STANDARD-TRIUMPH MOTOR COMPANY, INC.

TO: ALL TRIUMPH DEALERS - WESTERN ZONE

BULLETIN T-63-64

SUBJECT: CLUTCH REPLACEMENTS

FIG. 1

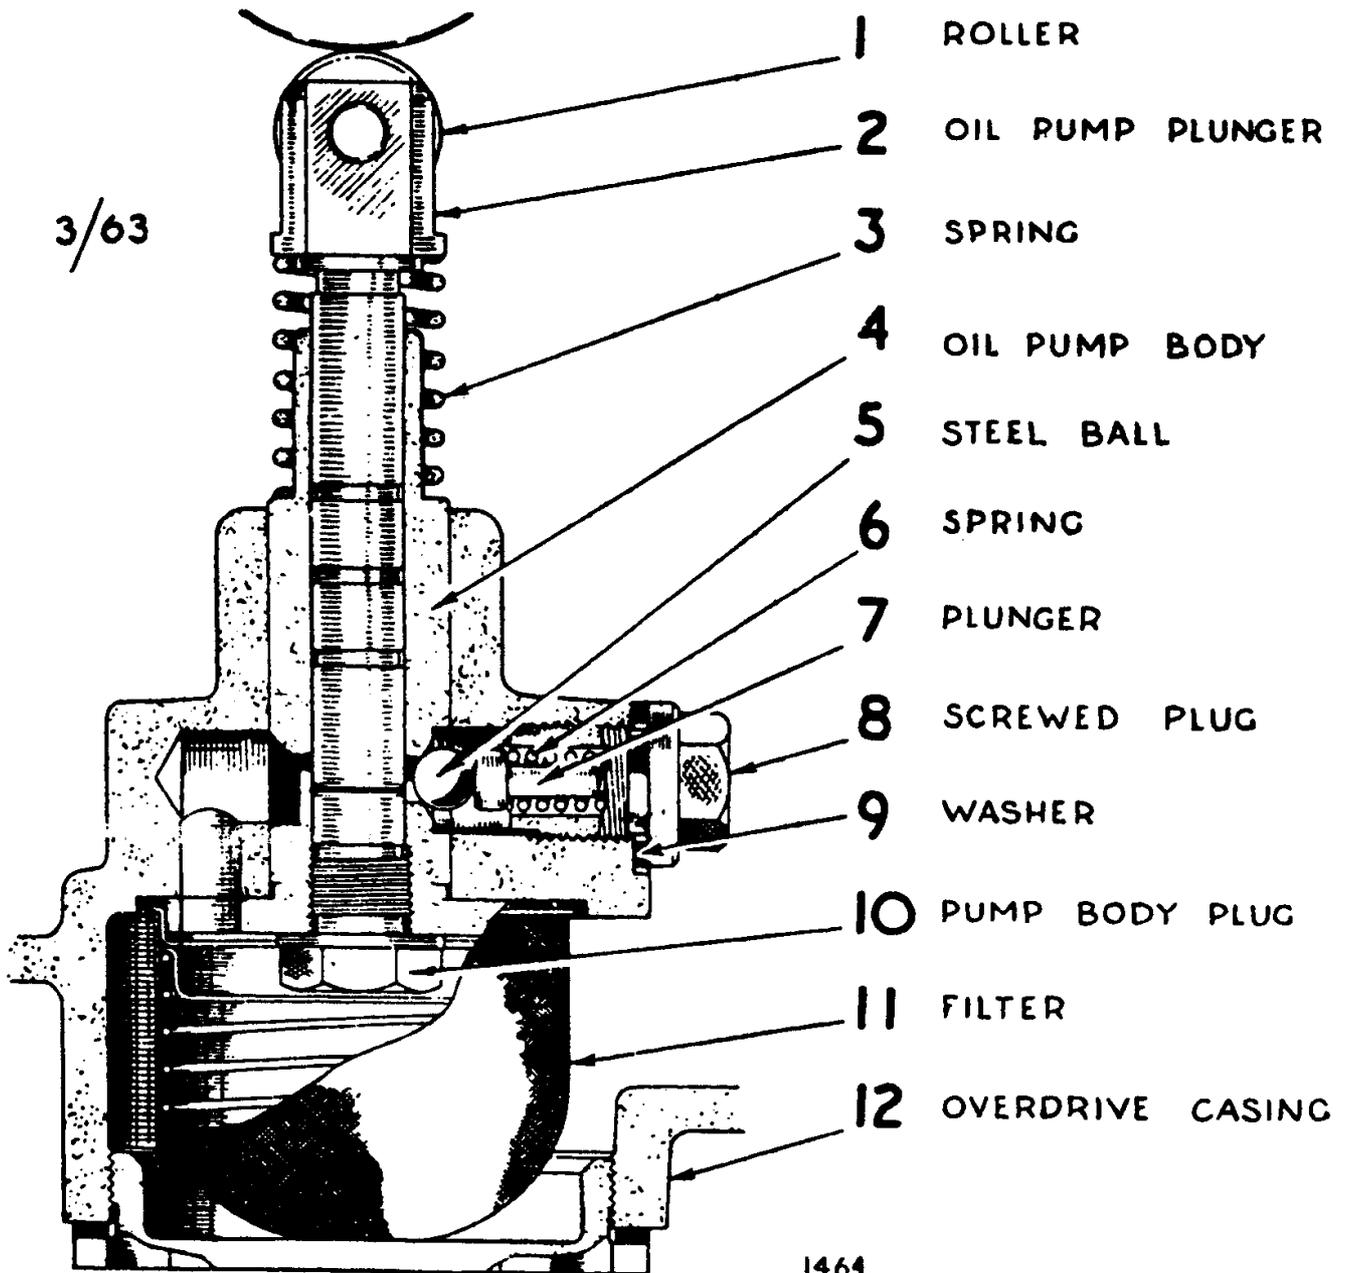
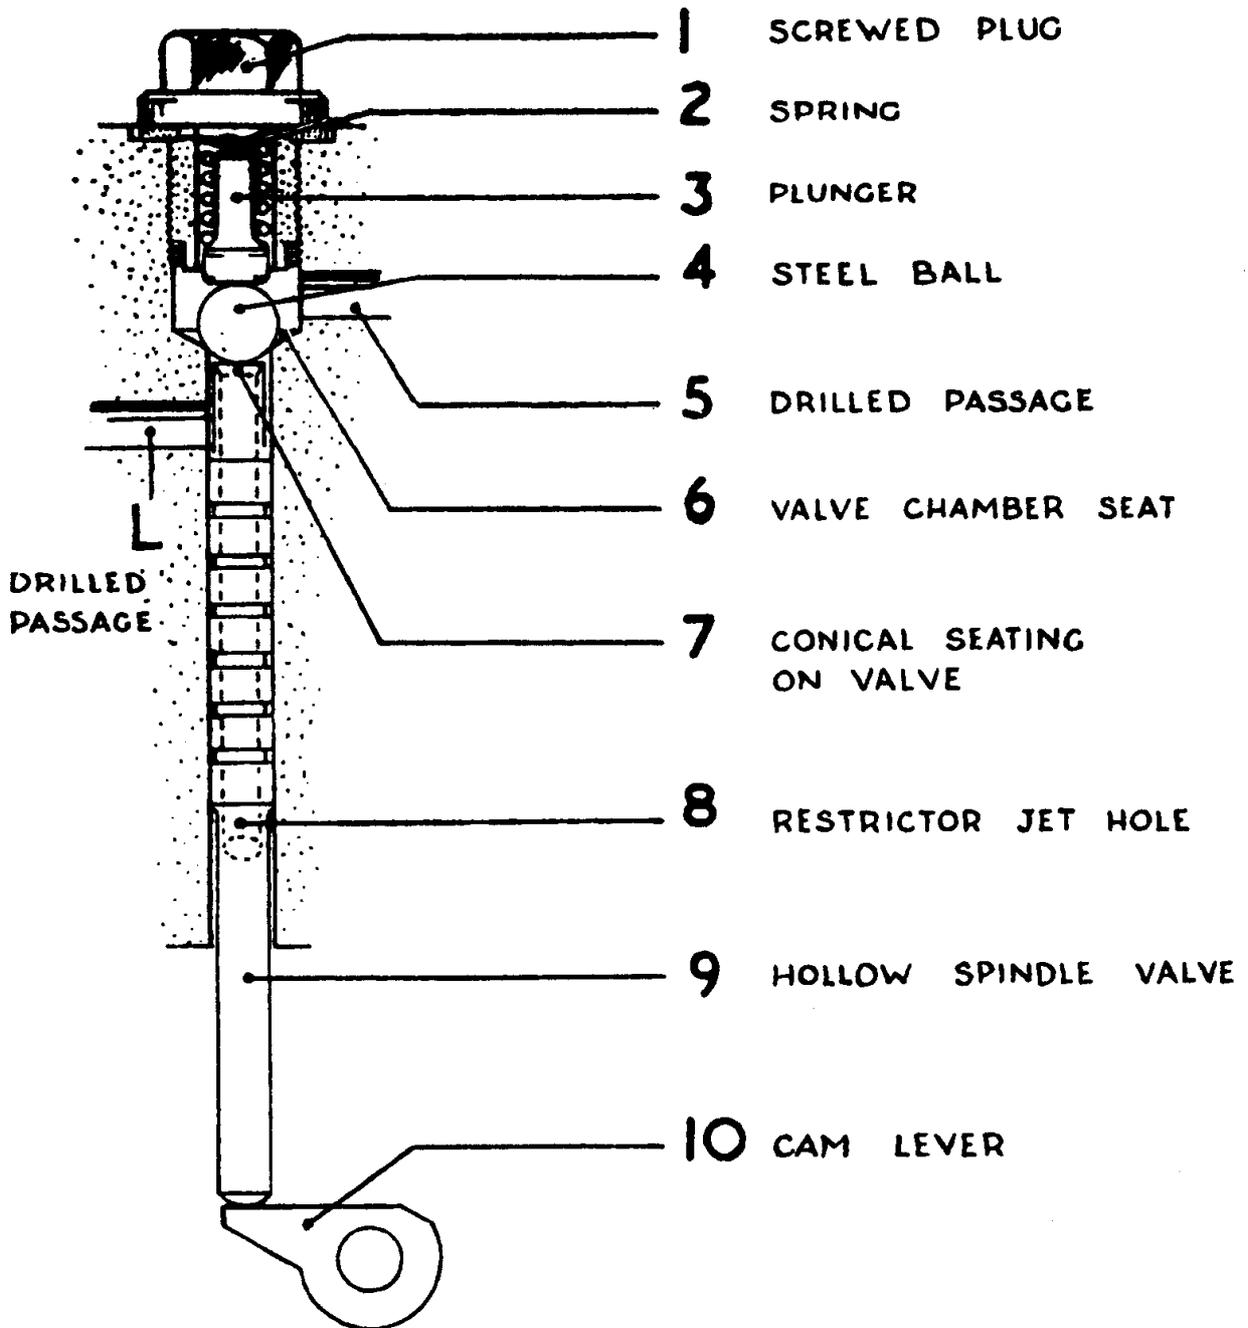
For adjusting the solenoid on "D" type see Service Bulletin 1-63-60. PUMP NON-RETURN VALVE (Figure 1)

In "A" type units access to the valve necessitates removal of the solenoid and solenoid bracket. The bracket is secured by two 5/16" (7.937 mm.) diameter studs and two t/16" (7.937 mm.) diameter bolts, the head of the bolts being painted RED. THE NUTS MUST BE REMOVED FROM THE STUDS BEFORE TOUCHING THE BOLTS. The two bolts should not be slackened off together releasing the compression on the accumulator spring which abuts the solenoid bracket.

After removing the valve plug, spring, plunger and ball, clean the seat and reset the ball by giving it a sharp tap with a suitable hammer and drift.

The "D" type has a detachable pump valve accessible from beneath the unit when the center plug is removed. The valve body can then be withdrawn by inserting a piece of stiff wire, bent into a hook, in the hole in the side of the body. After removal of the body, the valve plunger can be pushed out. Inspect the body, plunger, spring and "O" ring for damage. The plunger should be a sliding fit in the body.

The operating valve plug is located on top of the unit. Release hydraulic pressure, unscrew plug and remove spring, plunger and ball. A small magnet will be found useful for this operation. Remove operating valve by inserting a stiff piece of wire and drawing it up. Near the bottom of the valve will be seen a small hole breaking through the center drilling. Ensure that this is not choked (Figure 2).

If necessary, the ball can be resealed on top of the operating valve by placing the ball on a block of wood and sharply tapping the valve after positioning it on the ball. Clean the valve seat in the casing and if necessary reseat the ball by tapping it gently on its seat with a copper drift. Do not tap the ball too hard or the mouth of the hole will be closed up so that the valve cannot be reassembled.

SUBJECT: TRIUMPH TR-4 WINDOW
WINDER REGULATOR

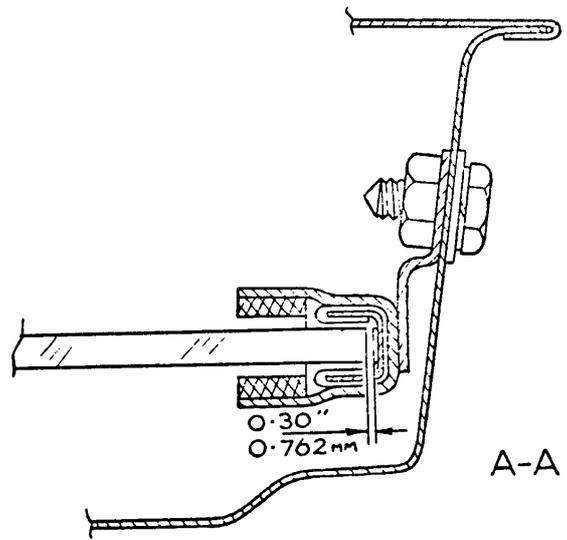
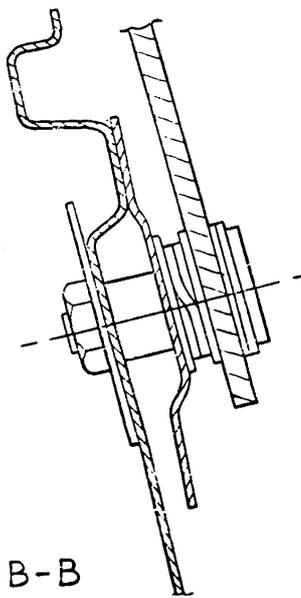
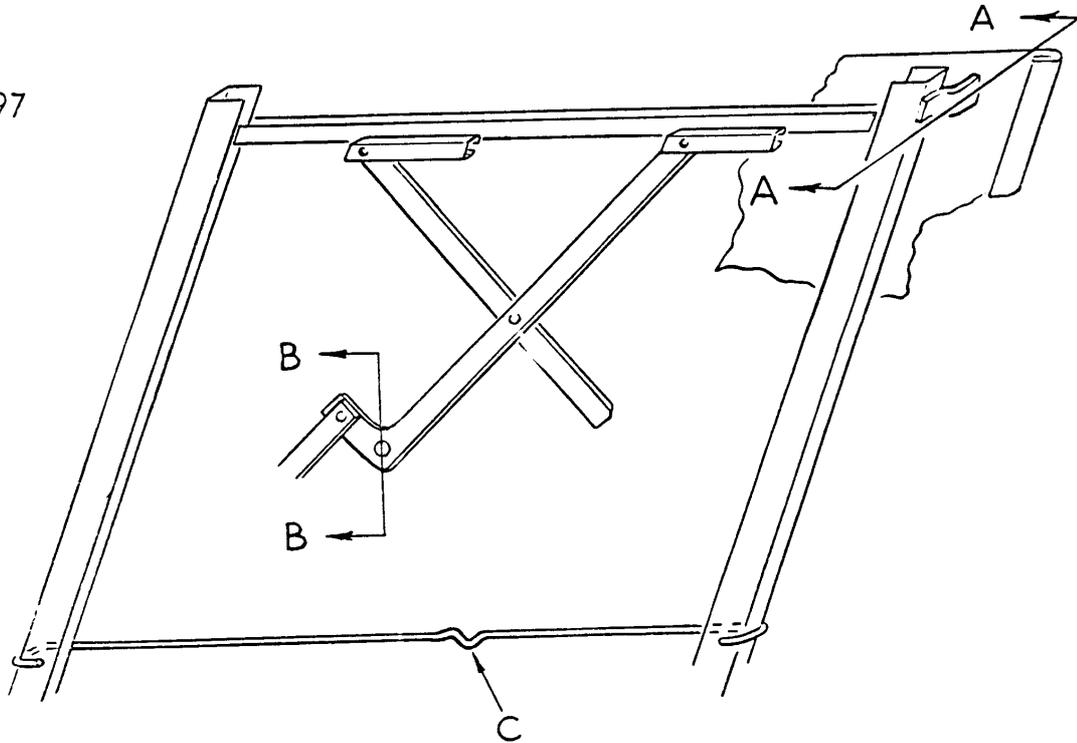
When reports of stiffness in the operation of the door glass are received, the following procedure should be adopted which will prevent straining and damage to the regulator. The same instructions should also be followed when renewing a regulator.

1. Remove trim panel.
2. Raise window and check the clearance of the glass fore and aft in the top of the rear channel. The recommended clearance is .030" which should be maintained for the whole length of the channel. Excess clearance will allow tilting and the jamming of the glass and insufficient clearance will produce stiff operation. Clearance can be obtained by the use of packing washers between the inner door panel and top channel bracket (see illustration A-A).

3. Adjust bottom brackets and crimp the tie rod to ensure that the channels are parallel (illustration C).
4. Remove regulator pivot pin nut and delete spring washer under head of nut. Add washer WP0119 1/2"x 7/8" x .050" behind head of pivot bolt and additional washer WP0160 5/16" x 1 5/8" x 16 S.W.G. behind head of nut (illustration B-B).

5. Tighten nut sufficiently to allow ease of operation and peen or center pop end of thread.
6. Refit trim.

T-67-14

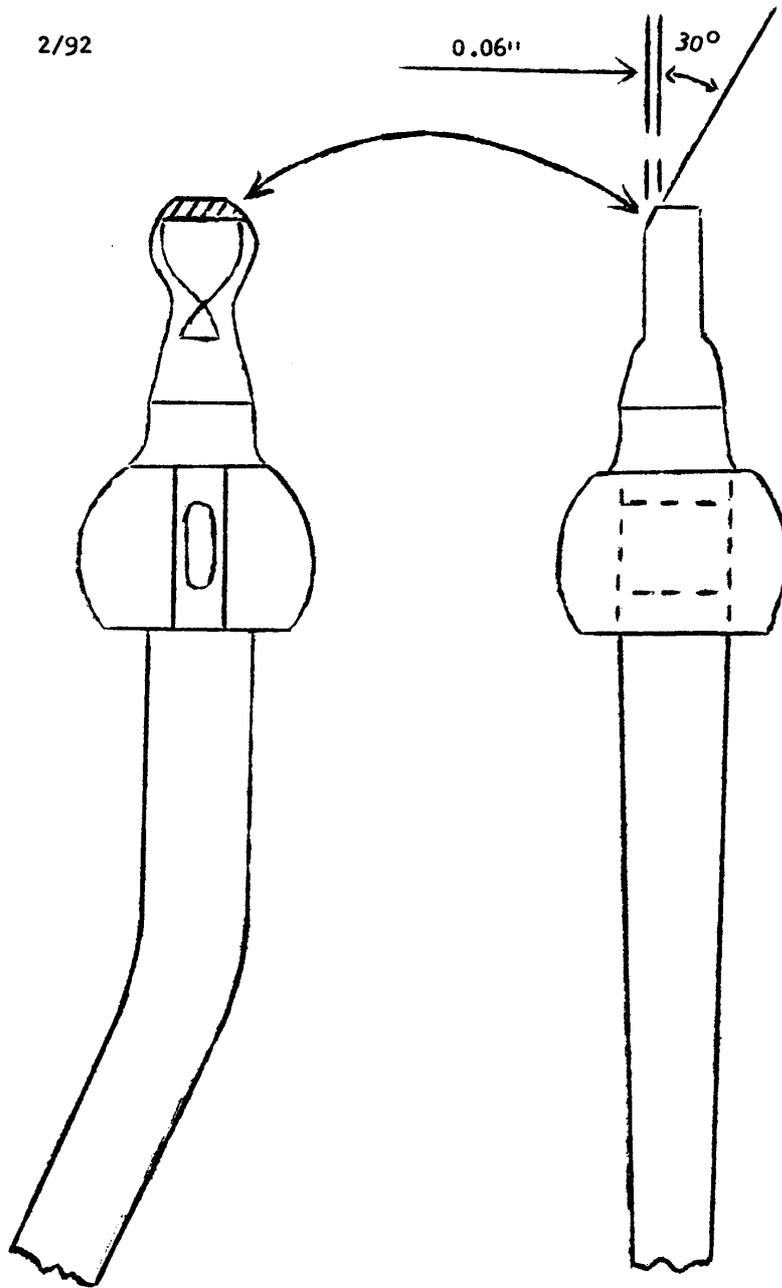
To overcome complaints of gear lever rattle on the TR-4 and TR-4A range of cars, the following modification can be carried out.

- (a) Remove gearbox lid, dismantle the gear lever and reverse selector shaft.
- (b) Remove reverse selector, part number 127385, and replace with modified selector under the same part number. (Current parts stocks will all be to the modified condition.)

The ramp of the modified selector is chamfered off to enable reverse gear to be selected by knocking the lever over, instead of lifting it into position. This is necessary due to the heavy type spring fitted.

- (c) Grind a small 30° chamfer on the side of the ball end of the gear lever adjacent to the reverse selector.. This is necessary to assist the "knock over" action. (See illustration attached)
- (d) Lubricate and assemble all parts, but replace the original gear lever spring with the heavier type, part number 145472. Ensure that the small plunger and spring in the ball end of the lever do not become displaced on assembly.

Gear lever spring	Part number 145472
Reverse selector (modified)	Part number 127385
